MOODY•NOLAN	4415 Euclid Avenue Suite 100 Cleveland, OH 44103 Phone: (216) 432-0696 Fax: (216) 432-0699	CHILDREN'S SCHOOL OF ROCHESTER - ADDITION/RENOVATION 85 Hillside Ave, Rochester, NY 14610 FOR Rochester Joint Schools Construction Board SED No. 26-16-00-01-0-001-022	ADDENDUM #3 SK-1 THRU SK-5 SHEET REVISED
	SKETCH NUMBER <h1>SK-1</h1>		PROJ # 16307.01
		DRAWN BY CS	DATE 05/24/2017

ADDENDUM #3 SHEET REVISED
SK-1 THRU SK-5

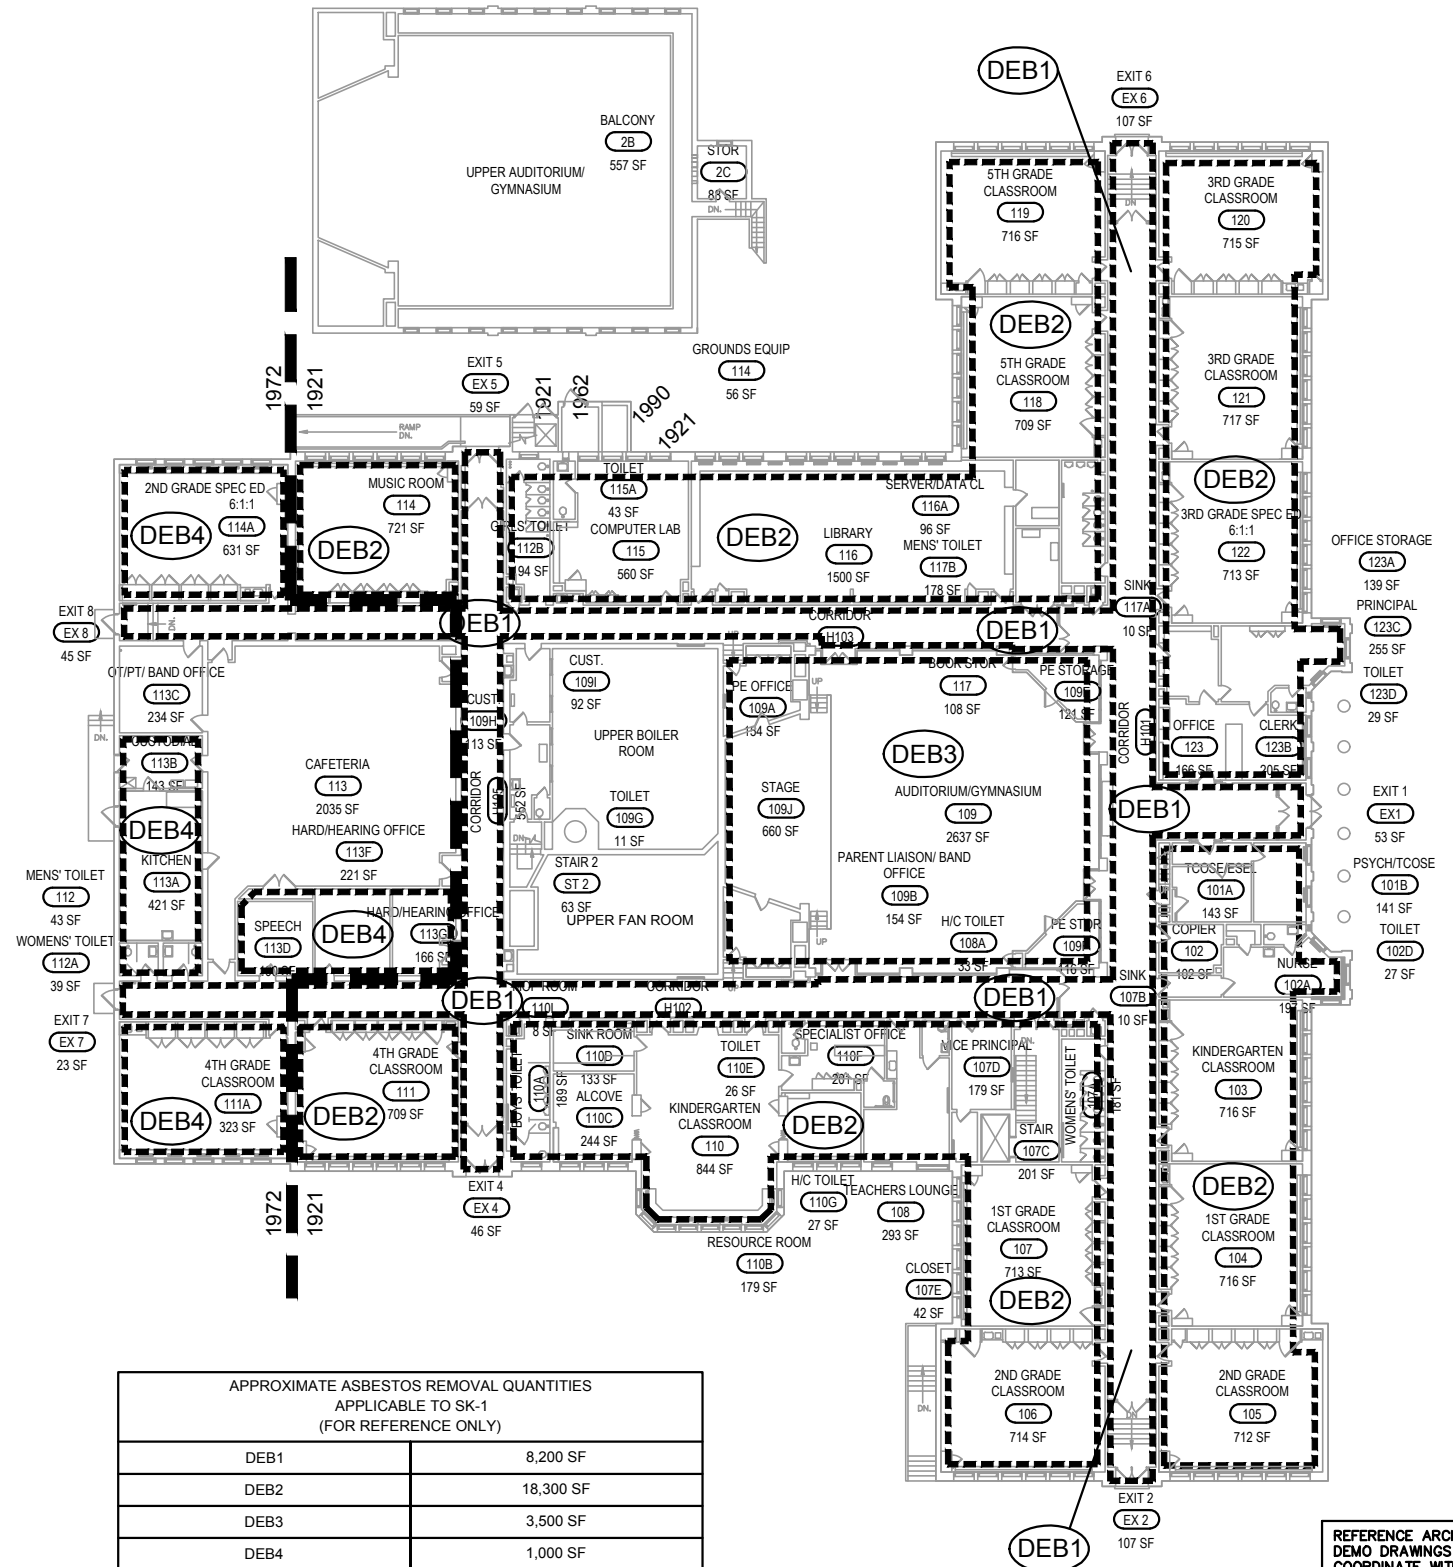
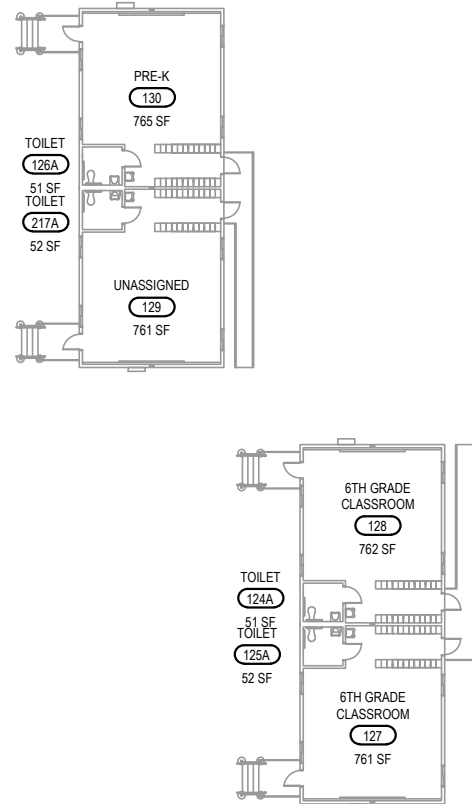
- DEB1 CORRIDOR REMOVALS.** OTHERS TO REMOVE NON-AC ACOUSTICAL CEILING TILE INCLUDING LIGHT FIXTURES, LOUVERS, CEILING SUPPORT SYSTEM AND ANY OTHER APPURTENANCES ATTACHED TO THE CEILING IN ENTIRETY WITHIN CORRIDOR AND DISPOSE OF AS CONSTRUCTION DEBRIS. OTHERS TO REMOVE NON-AC PLASTER AND LATHE CEILING, WOOD CEILING JOISTS, LOWER PLENUM IN ENTIRETY, AND DISPOSE OF AS CONSTRUCTION DEBRIS. CONTRACTOR TO PLASTICIZE FLOORS AND WALLS UP TO UPPER PLENUM. CONTRACTOR TO REMOVE PERIMETER NON-AC PLASTER AND LATHE CEILINGS, UPPER PLENUM, CONTAMINATED WITH AC ROOFING DEBRIS AND DISPOSE OF AS AN ACM. CONTRACTOR TO INSTALL CRITICAL BARRIERS IN UPPER PLENUM. CONTRACTOR TO REMOVE REMAINING ASBESTOS CONTAMINATED PLASTER AND LATHE CEILING AND DISPOSE OF AS AN ACM. (1) LAYER OF WOOD RAFTERS AND (1) LAYER OF WOOD FRAMED OVERBUILD, AND TONGUE/GROOVE ROOF SHEATHING IN SECOND PLENUM CORRIDORS SHALL REMAIN UNDAMAGED AND BE DECONTAMINATED USING HEPA-VACUUMS AND WET CLEANING METHODS. ANY REMAINING FRAMING OR EDGING IN THE CEILING PLENUM SHALL BE DECONTAMINATED USING HEPA-VACUUMS AND WET CLEANING METHODS.

- DEB2 CLASSROOM REMOVALS.** OTHERS TO REMOVE NON-AC ACOUSTICAL CEILING TILE INCLUDING LIGHT FIXTURES, LOUVERS, CEILING SUPPORT SYSTEM AND ANY OTHER APPURTENANCES ATTACHED TO THE CEILING IN ENTIRETY WITHIN CLASSROOMS AND DISPOSE OF AS CONSTRUCTION DEBRIS. CONTRACTOR TO PLASTICIZE FLOORS AND WALLS UP TO THE METAL CEILING. REMOVE PERIMETER CEILINGS AND ASSOCIATED NON-AC TAR PAPER CONTAMINATED WITH AC ROOFING DEBRIS AND DISPOSE OF AS AN ACM. PLASTICIZE WALLS TO ROOF DECK. CONTRACTOR TO REMOVE REMAINING ASBESTOS CONTAMINATED METAL CEILING. METAL CEILINGS SHALL BE SALVAGED AND TURNED OVER TO OWNER AS REQUIRED TO PROVIDE FOR REUSE. CONTRACTOR SHALL CAREFULLY SALVAGE WHOLE METAL PANELS PROVIDING MINIMAL TO NO DAMAGE IN THE AMOUNT OF 1,000 SF. THE REMAINING CEILINGS SHALL BE DECONTAMINATED AND DISPOSED OF AS CONSTRUCTION DEBRIS. (1) LAYER OF WOOD RAFTERS AND (1) LAYER OF WOOD FRAMED OVERBUILD, AND TONGUE/GROOVE ROOF SHEATHING SHALL REMAIN UNDAMAGED AND BE DECONTAMINATED USING HEPA-VACUUMS AND WET CLEANING METHODS. ANY REMAINING FRAMING OR EDGING IN THE CEILING PLENUM SHALL BE DECONTAMINATED USING HEPA-VACUUMS AND WET CLEANING METHODS.

- DEB3 AUDITORIUM/GYMNASIUM/STAGE REMOVALS.** OTHERS TO REMOVE NON-AC ACOUSTICAL CEILING TILE INCLUDING LIGHT FIXTURES, LOUVERS, CEILING SUPPORT SYSTEM AND ANY OTHER APPURTENANCES ATTACHED TO THE CEILING IN ENTIRETY WITHIN AUDITORIUM/GYMNASIUM/STAGE AND DISPOSE OF AS CONSTRUCTION DEBRIS. CONTRACTOR TO PLASTICIZE WORKING SURFACES AND WALLS UP TO NON-AC PLASTER CEILING. CONTRACTOR TO REMOVE PERIMETER NON-AC PLASTER AND LATHE CEILINGS CONTAMINATED WITH AC ROOFING DEBRIS AND DISPOSE OF AS AN ACM. CONTRACTOR TO INSTALL CRITICAL BARRIERS IN UPPER PLENUM. REMOVE REMAINING ASBESTOS CONTAMINATED PLASTER AND LATHE CEILING AND DISPOSE OF AS AN ACM. (1) LAYER OF WOOD RAFTERS AND (1) LAYER OF WOOD FRAMED OVERBUILD, AND TONGUE/GROOVE ROOF SHEATHING SHALL REMAIN UNDAMAGED AND BE DECONTAMINATED USING HEPA-VACUUMS AND WET CLEANING METHODS. ANY REMAINING FRAMING OR EDGING IN THE CEILING PLENUM SHALL BE DECONTAMINATED USING HEPA-VACUUMS AND WET CLEANING METHODS.

- DEB4 1972 ADDITION CLASSROOMS AND KITCHEN AREA REMOVALS.** CONTRACTOR TO PLASTICIZE WORKING SURFACES AND WALLS UP TO ASBESTOS CONTAMINATED ACOUSTICAL CEILING TILES AND/OR HARD CEILING BOARD. CONTRACTOR TO REMOVE PERIMETER ACOUSTICAL CEILING TILES AND DISPOSE OF AS AN ACM. CONTRACTOR TO INSTALL CRITICAL BARRIERS IN PLENUM. CONTRACTOR TO REMOVE REMAINING ACOUSTICAL CEILING TILES CONTAMINATED WITH AC ROOFING DEBRIS INCLUDING LIGHT FIXTURES, LOUVERS, CEILING SUPPORT SYSTEM, AND ANY OTHER APPURTENANCES ATTACHED TO THE CEILING IN ENTIRETY AND DISPOSE OF AS AN ACM. ANY REMAINING FRAMING OR EDGING IN THE CEILING PLENUM SHALL BE DECONTAMINATED USING HEPA-VACUUMS AND WET CLEANING METHODS.
